TK Elevator EOX

The following shows some examples of what should be done & how to prove that the work was performed.

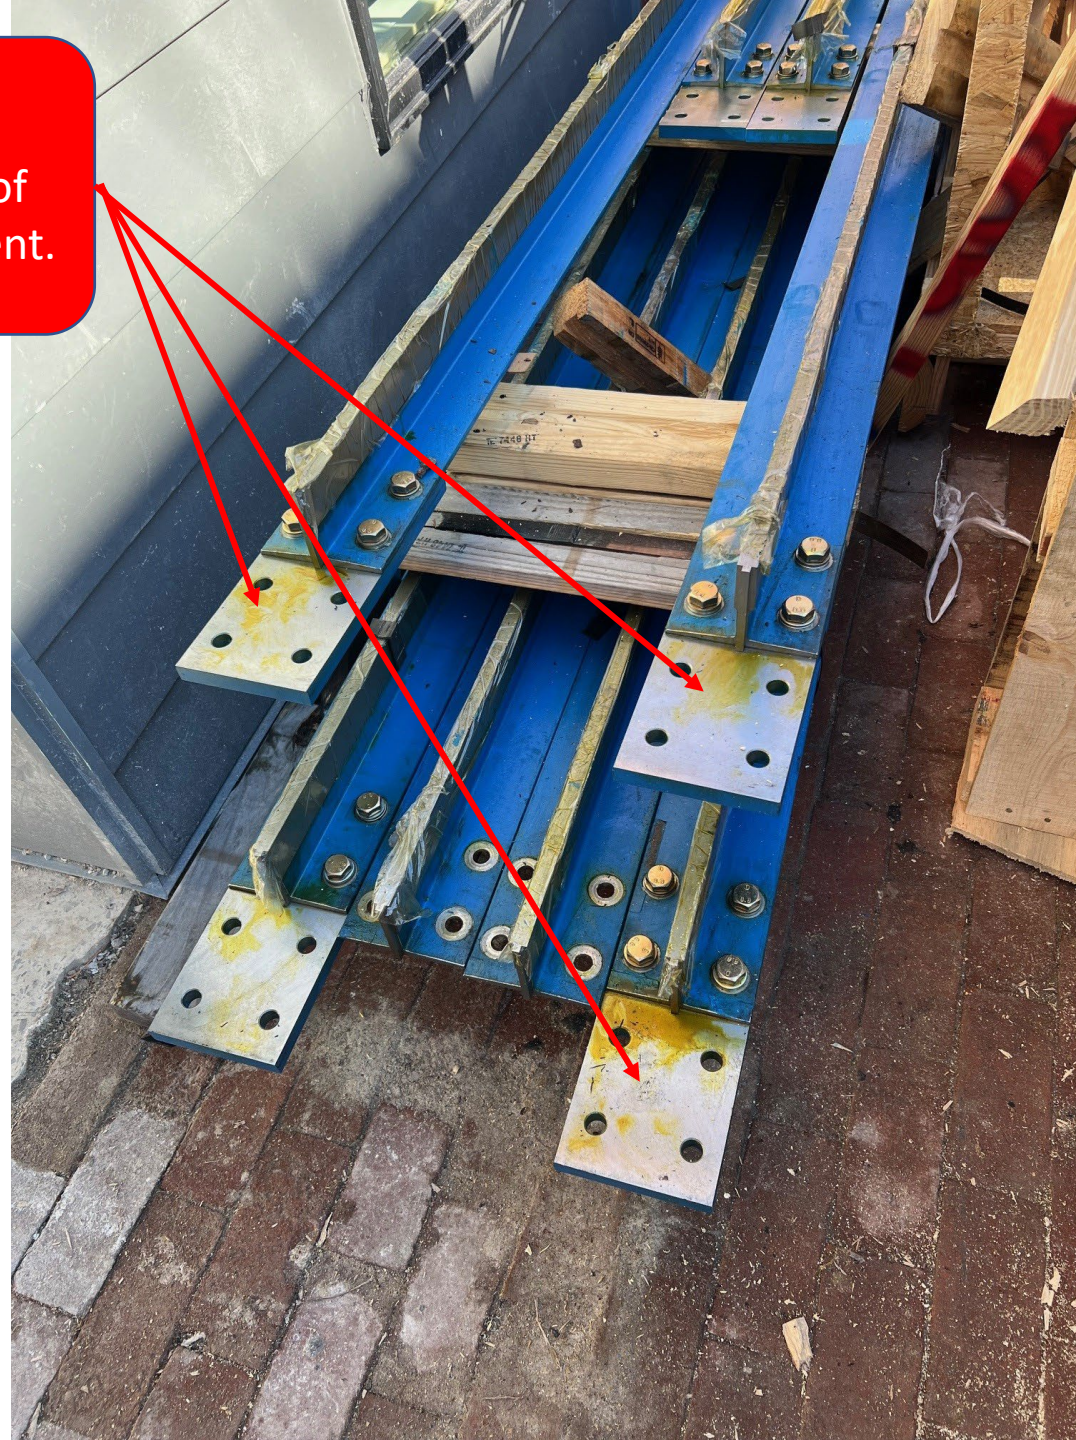
Raceway factory assembled. Violation of Article IV, Par. 2 (d) of the collective bargaining agreement and the 2017 Endura Arbitration Decision.

(d) All wiring, conduit, and raceways from main line feeder terminals on the controller to other elevator apparatus and operating circuits. Controllers are not to be shipped from the factory with extended wiring attached thereto.

Disassemble and reassemble, making marks with a paint/permanent marker that proves it was taken apart.

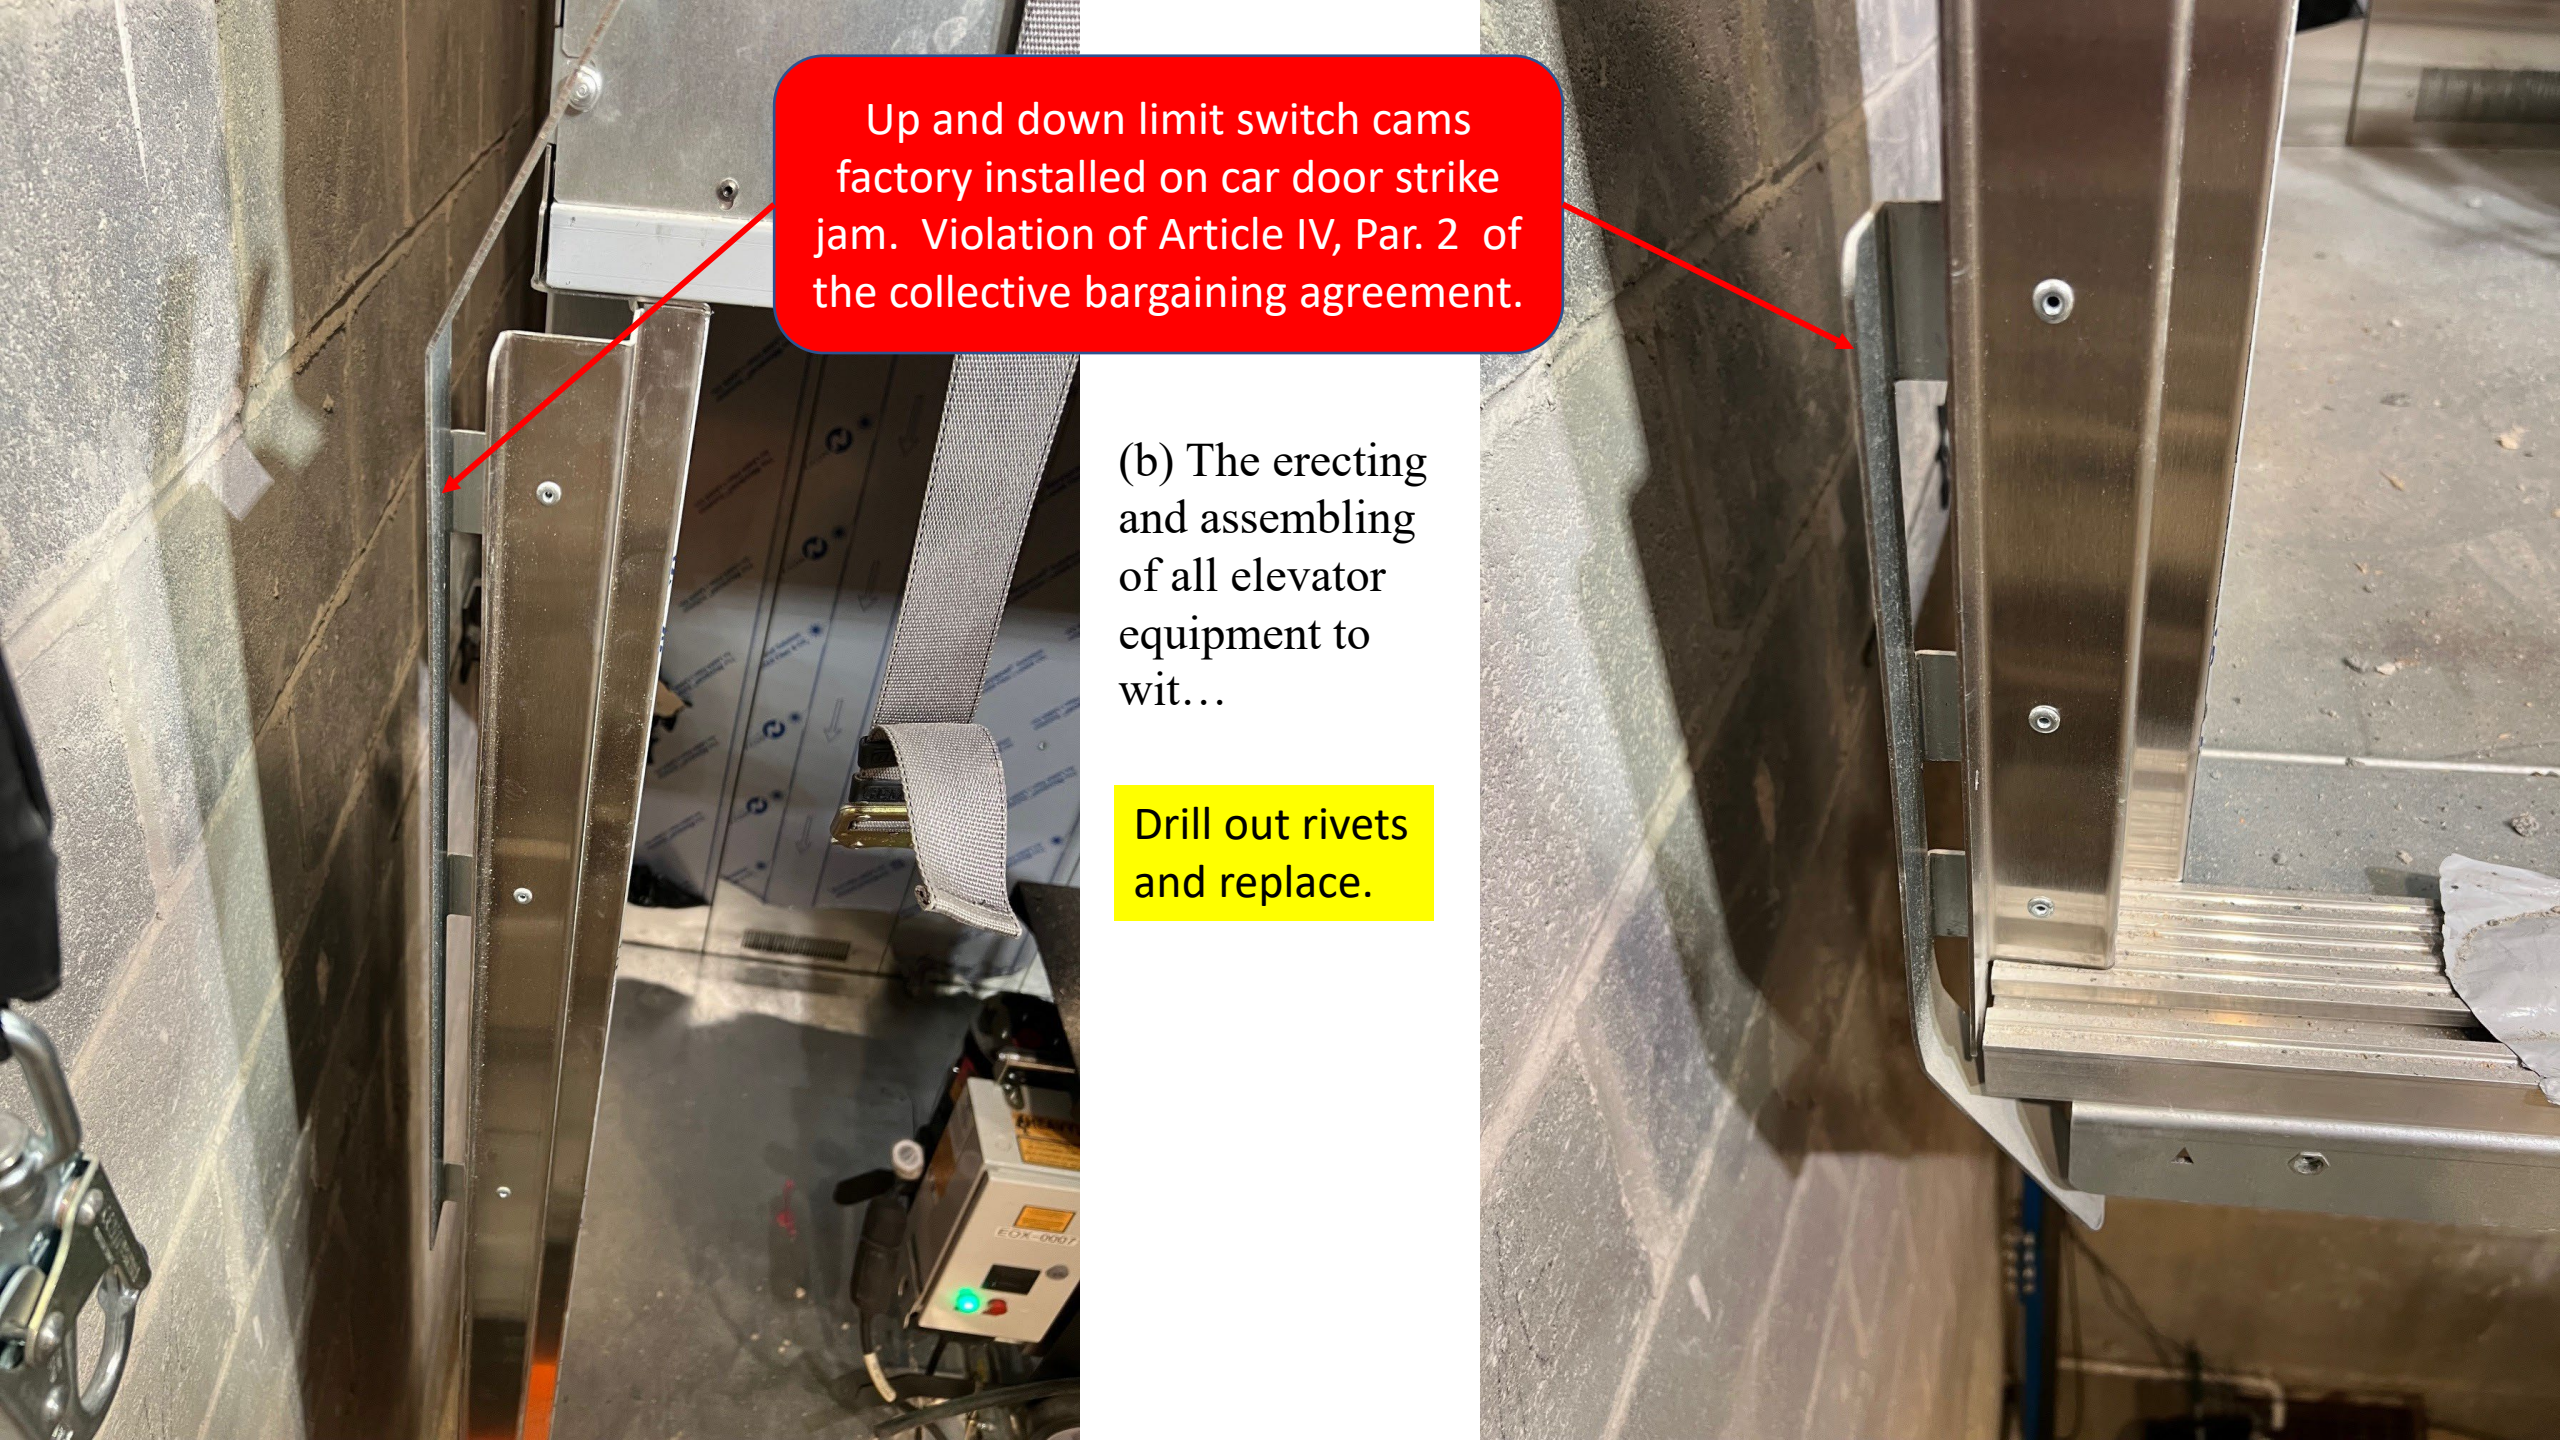
Safety operated switch factory installed, piped and wired. Violation of Article IV, Par. 2 (d) of the collective bargaining agreement.

(d) All wiring, conduit, and raceways from main line feeder terminals on the controller to other elevator apparatus and operating circuits. Controllers are not to be shipped from the factory with extended wiring attached thereto.

Take apart and reassemble. Place marks showing both the flex and box connector were removed. Undo wiring and place a mark below the terminals where the wires would prevent marking if they were attached.

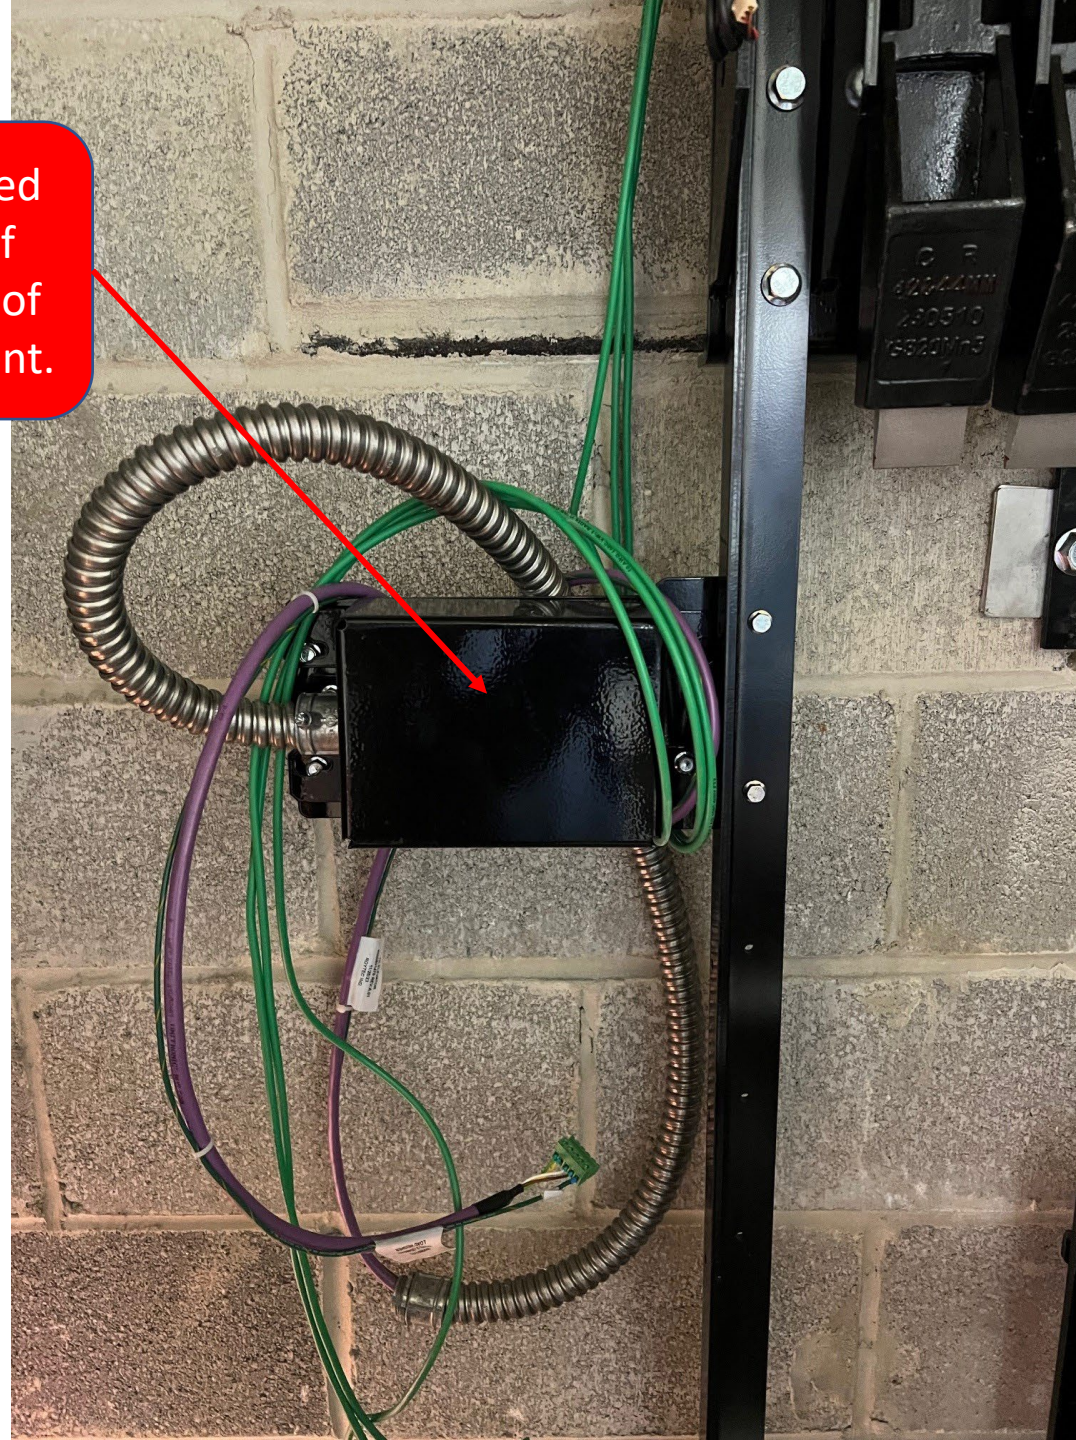
Load weighing switch factory piped and plug connector. Violation of Article IV, Par. 2 (d) and Par. 3 (7) of the collective bargaining agreement.

(d) All wiring, conduit, and raceways from main line feeder terminals on the controller to other elevator apparatus and operating circuits. Controllers are not to be shipped from the factory with extended wiring attached thereto.

(7) Preassembled plug connectors may be used to interconnect the solid state components of the elevator systems and to connect any component in and on the car.

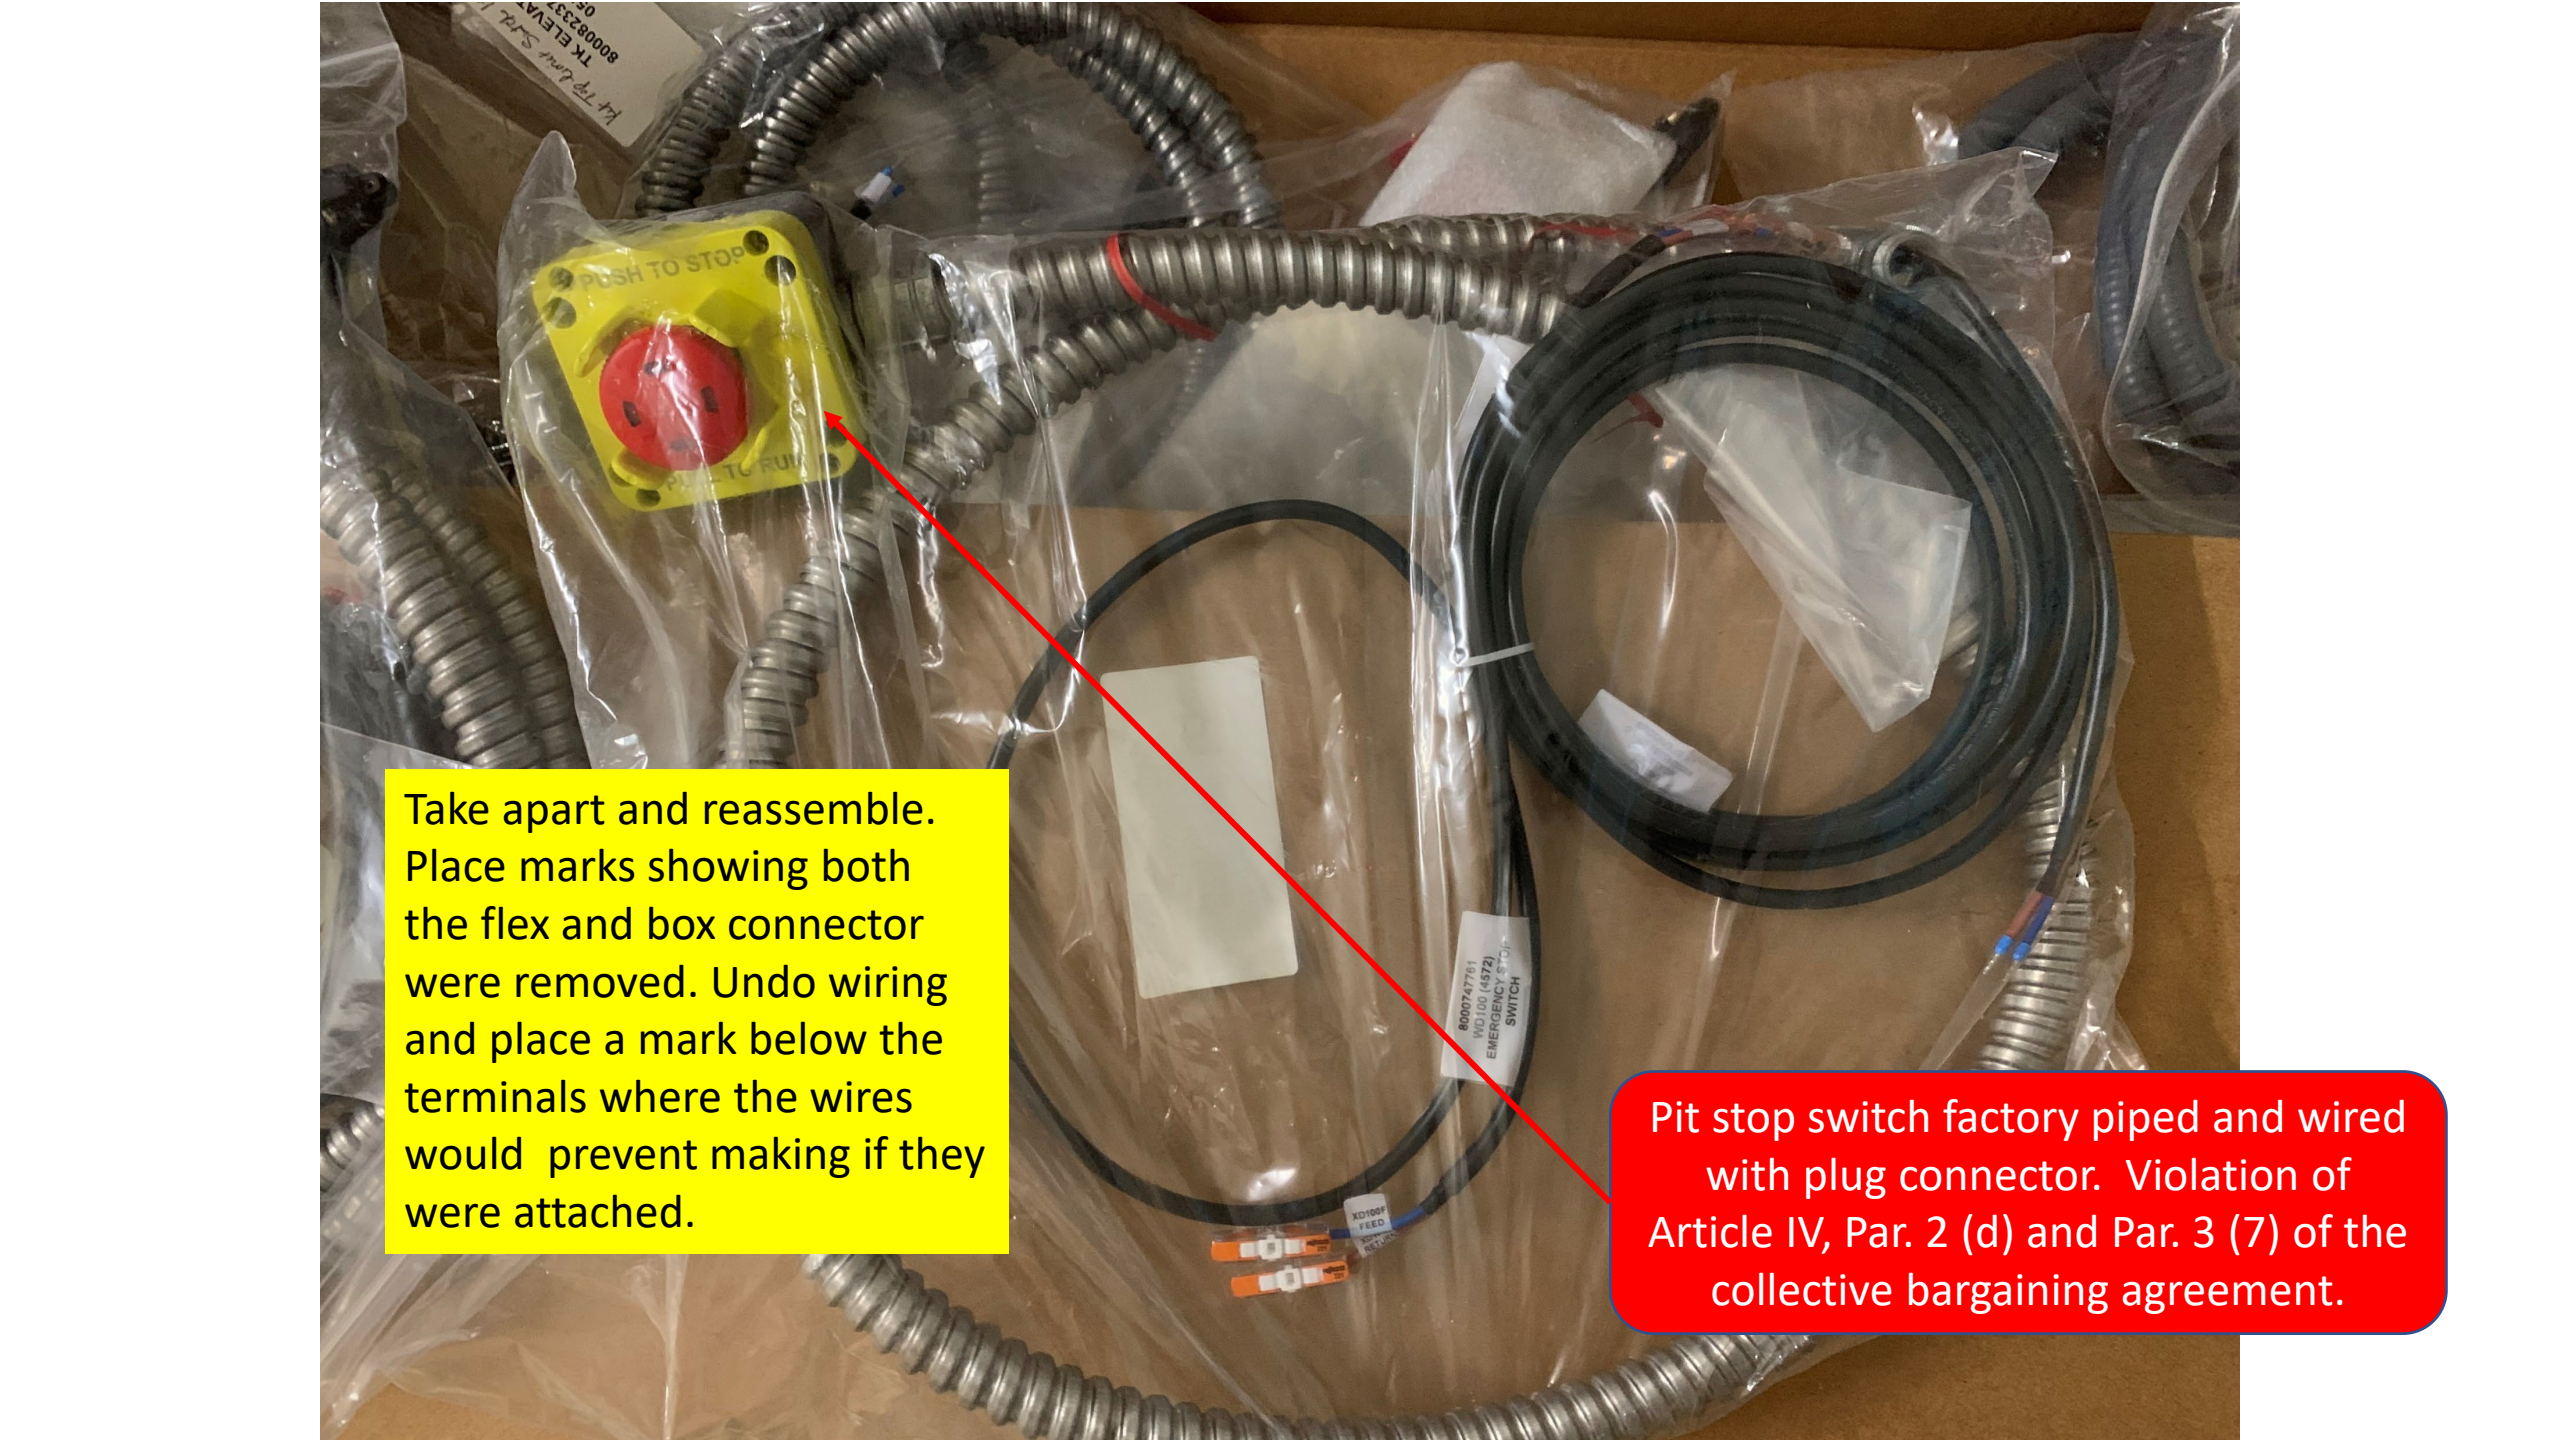
Up and down terminal limit switches
factory piped and wired with plug
connector. Violation of Article IV,
Par. 2 (d) and Par. 3 (7) of the
collective bargaining agreement.

Take apart and reassemble.
Place marks showing the flex,
box connector and bracket
were removed. Undo wiring
and place a mark below the
terminals where the wires
would prevent marking if
they were attached.
